# Access Compliance Report

## Public Rights-of-Way

### (Curb Ramps)

Intersection ID: 5946	Main Street: CONIFER_CR	Cross Street: FAIRES_FARM_RD	Location: W
ADA ID: 9C24FF368293	Ramp Type: PerpDiag	Initial Pass/Fail: Fail	Overall Compliance: No
Codes/Mitigation Info/Possible Solution			Severity Score: 25
			Field Measurements/Component Compliance

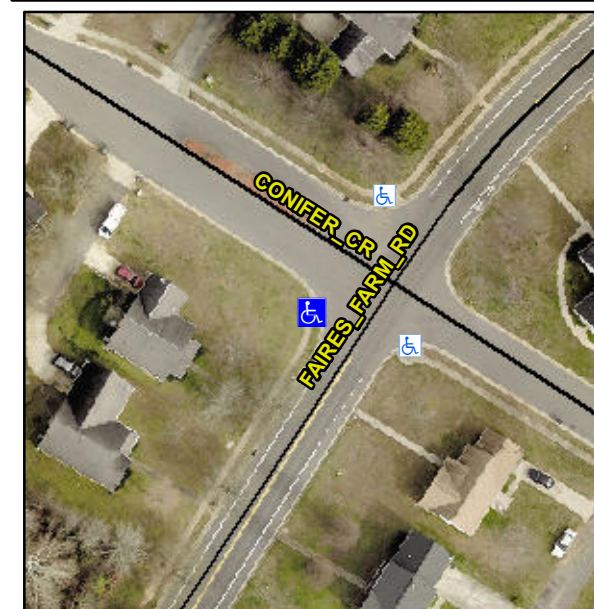
**R304.2.2, R304.5.3**

Compliance	Description	Data	Compliance	Description	Data
N/A	Ramp Length (in)	51.0	No	Ramp Slope (%)	9.4
Yes	Ramp Width (in)	48.0	No	Ramp XSlope (%)	5.4
N/A	Flare Type LT	N/A	N/A	Flare Type RT	N/A
N/A	Flare Slope LT (%)	N/A	N/A	Flare Slope RT (%)	N/A
N/A	Flare Traversable LT?	N/A	N/A	Flare Traversable RT?	N/A
N/A	Landing Length (in)	N/A	N/A	DWS Provided?	N/A
N/A	Landing Width (in)	N/A	N/A	DWS Contrast?	N/A
N/A	Landing Slope (%)	N/A	N/A	DWS Length (in)	N/A
N/A	Landing X Slope (%)	N/A	N/A	DWS Full Width?	N/A
N/A	Landing Curb? (Y/N)	N/A	N/A	DWS Offset (in)	N/A
N/A	Shared Landing?	N/A			
N/A	Gutter Ponding?	N/A	N/A	Gutter Slope (%)	N/A
N/A	Gutter Lip Ht (in)	N/A	N/A	Gutter X Slope (%)	N/A
N/A	Painted X Walk1?	No	N/A	Painted X Walk2?	No
	X Walk 1 Direction	To S		X Walk 2 Direction	To N
N/A	X Walk 1 Width (in)	N/A	N/A	X Walk 2 Width (in)	N/A
	X Walk 1 Slope (%)	1.1		X Walk 2 Slope (%)	5.9
	X Walk 1 X Slope (%)	5.3		X Walk 2 X Slope (%)	4.6

N/A	Ramp inside XWalk1?	N/A	N/A	Ramp inside XWalk2?	N/A
	Road Slope (%)	6.7	N/A	Clear Space?	N/A
	Road X Slope (%)	2.4	N/A	Clear Space to XWalk (in)	N/A
N/A	Any Obstructions?	N/A	N/A	Storm Grate/Utility Hazard?	N/A
	Obstruction Type			Storm Grate/Utility Type	
		N/A			N/A
		Yes		Surface Condition? (G/P)	Good

**Remove & Replace Curb Ramp With Two New Directional Ramps or Equivalent.**
